Dean LaForest
Manager of Strategic System Planning
Vermont Electric Power Company, Inc.
366 Pinnacle Ridge Road
Rutland, VT 05701
dlaforest@velco.com
Direct: 802-770-6323

RE: TCA Application Northwest Reliability Project Revision 1 – Request for Information #01
VELCO-03-155-01-R1, VELCO-03-155-02-R1, VELCO-03-155-03-R1, VELCO-03-155-04-R1

Please find attached the additional information requested for the revised Transmission Cost Allocation (“TCA”) Northwest Reliability Project application as requested on May 16th 2008. You will find below the questions/answers relating to project update as described in this revision.

"Granite Post NRP One-Line Diagram" provided as the last page of the TCA VELCO-03-155-02 R1 package

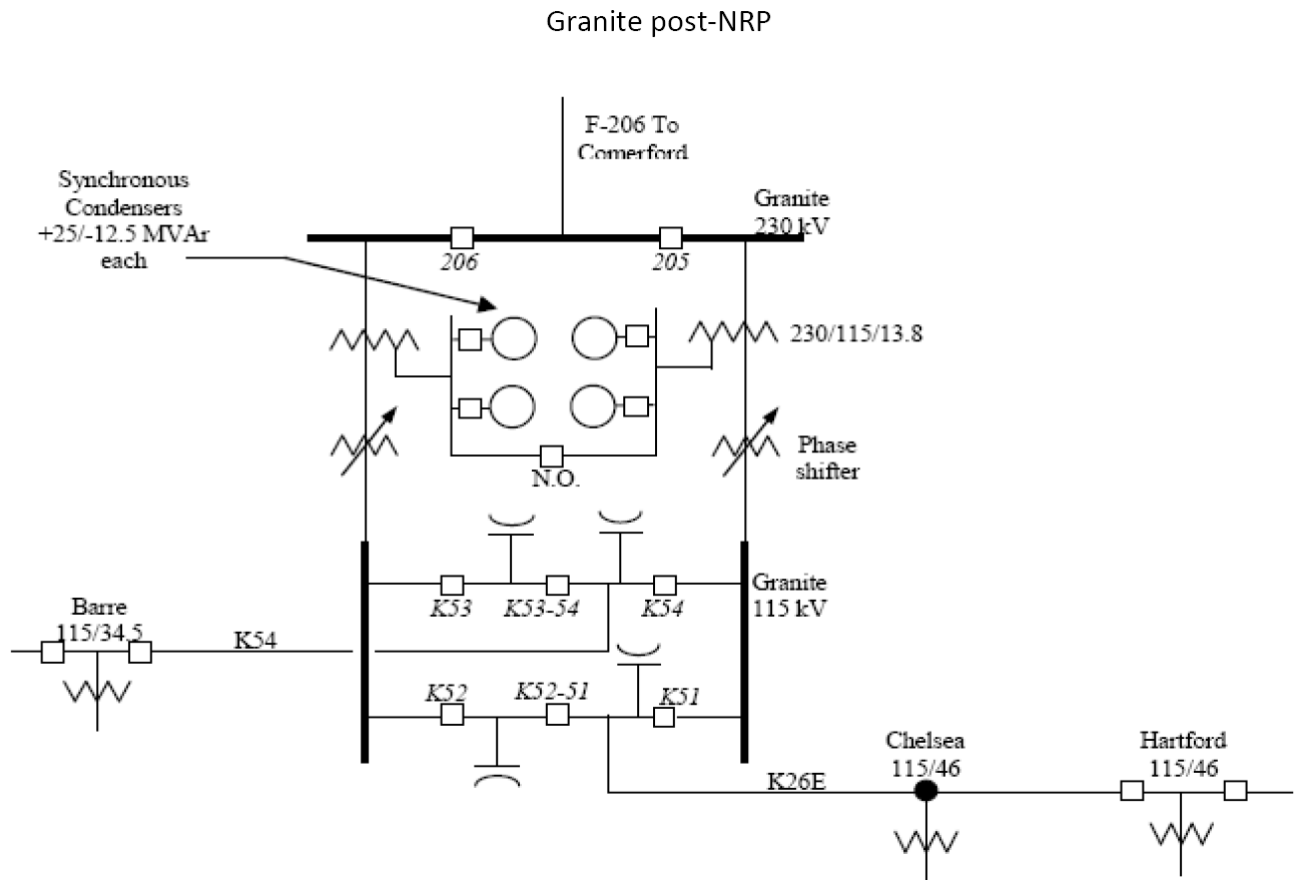
Q. C-5 Identify, using a circle placed on the "Granite Post NRP One-Line Diagram" provided as the last page of the TCA VELCO-03-155-02 R1 package, what spare DRD equipment was (or will be) installed, including the incremental cost of this spare equipment and the allocation to PTF and non-PTF requested costs.

A. C-5. There is no equipment on the “Granite Post NRP One-Line Diagram” provided as the last page of the TCA VELCO-03-155-02 R1 that was or will be installed as spare equipment. The indicated figure from TCA VELCO-03-155-02 R1 is reproduced below for reference.
